BUCKHEAD 3RD ADDITION

WICHITA, SEDGWICK COUNTY, KANSAS

Re: S/D 98-18 -- Final Plat of BUCKHEAD 3RD ADDITION

STAFF REPORT

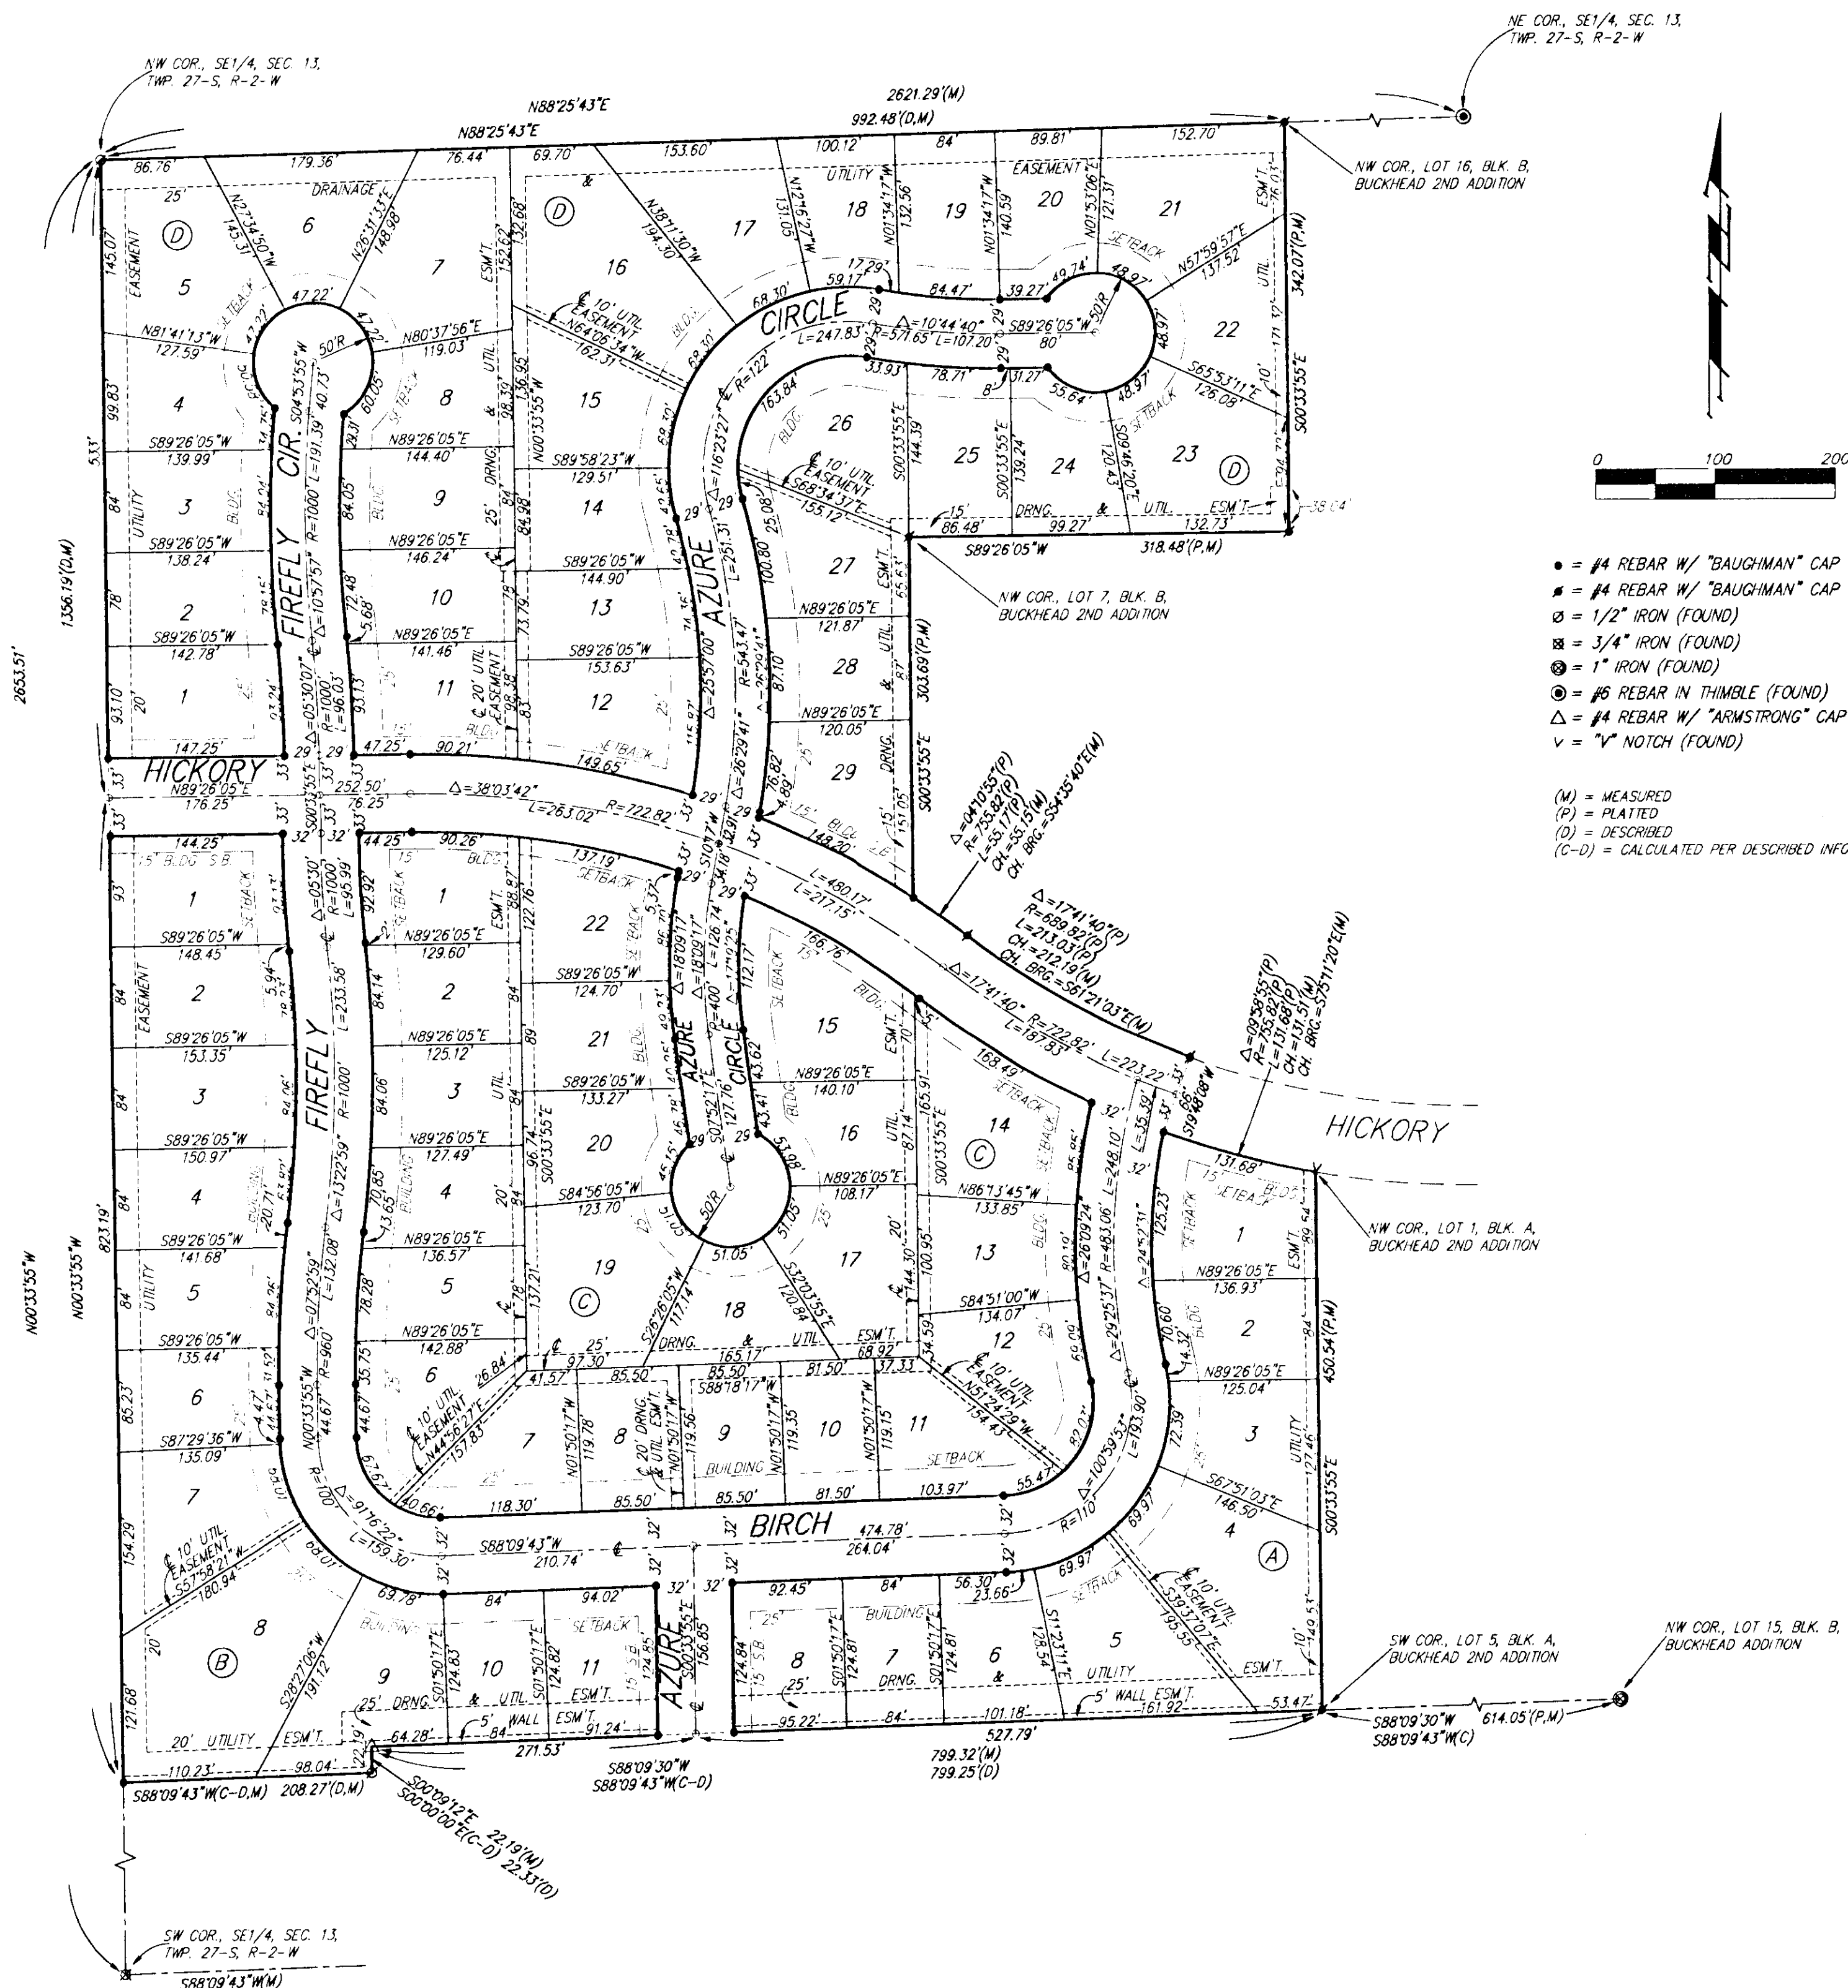
- C. City Engineering needs to comment on the status of the applicant's drainage plan. *The drainage plan is approved. Wherever storm sewer, sanitary sewer and other utilities share an easement, it is requested that the width of the easement be increased to 25 feet.*

- D. The applicant shall guarantee the paving of the proposed interior streets. This guarantee shall include the paving of Hickory to a collector status. Sidewalks shall be included in the guarantee providing for sidewalks on both sides of Hickory, and one side of the looped street Birch-Firefly.

- E. The representative from the City's Fire Department should also comment on the acceptability of the street names.
Firefly Court should be renamed Firefly Circle as it is a continuation of Firefly. Both streets named Azure Court should be renamed Azure Circle as they are extensions of Azure to the north.

- F. The applicant shall submit a covenant which provides for four (4) off-street parking spaces per dwelling unit on each lot which abuts a 58-foot street. The covenant shall inventory the affected lots by lot and block number and shall state that the covenant runs with the land and

- N. The representatives from the utility companies should be prepared to comment on the need for any additional utility easements to be platted on this property. **The representative from KG&E has requested additional easements.**
